Access Compliance Report

Public Rights-of-Way

Intersection ID: N/A	Main Street: RAINTREE_LN	Cross Street: ROUNDING_RUN_RD	Location: NW
ADA ID: 9EC12F6AC3DB	Ramp Type: Perp	Initial Pass/Fail: Fail	Overall Compliance: No
		Severity Score: 12.5

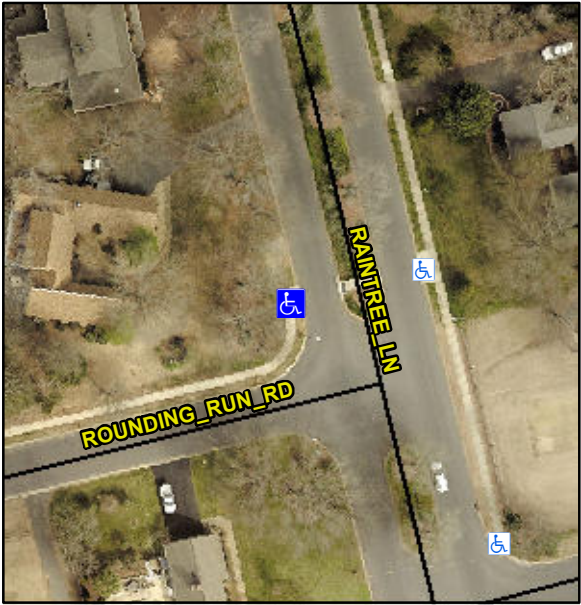
Codes/Mitigation Info/Possible Solution			Field Measurements/Component Compliance		
	Possible Solutions:		Compliance	Description	Data
	Remove & Replace Entire Ramp.		N/A	Ramp Length (in)	47.0
			Yes	Ramp Width (in)	60.0
			N/A	Flare Type LT	N/A
			N/A	Flare Slope LT (%)	N/A
			N/A	Flare Traversable LT?	N/A
			N/A	Landing Length (in)	N/A
			N/A	Landing Width (in)	N/A
			N/A	Landing Slope (%)	N/A
			N/A	Landing X Slope (%)	N/A
<p>Surveyor Notes:</p> <p>N/A</p> <p>PROW/ADA:</p> <p>R304.2.2</p>			N/A	Flare Type RT	N/A
			N/A	Flare Slope RT (%)	N/A
			N/A	Flare Traversable RT?	N/A
			N/A	DWS Provided?	N/A
			N/A	DWS Contrast?	N/A
			N/A	DWS Length (in)	N/A
			N/A	DWS Full Width?	N/A
			N/A	DWS Offset (in)	N/A
			N/A	Gutter Ponding?	N/A
			N/A	Gutter Lip Ht (in)	N/A
			N/A	Painted X Walk1?	No
				X Walk 1 Direction	To E
			N/A	X Walk 1 Width (in)	N/A
				X Walk 1 Slope (%)	4.2
				X Walk 1 X Slope (%)	2.9
			N/A	Ramp inside XWalk1?	N/A

Road Slope (%)	N/A
				Road X Slope (%)	N/A
			N/A	Any Obstructions?	N/A
				Obstruction Type	
Total Cost:			\$	1850.00	
					N/A
				Yes	Surface Condition? (G/P)
					Good
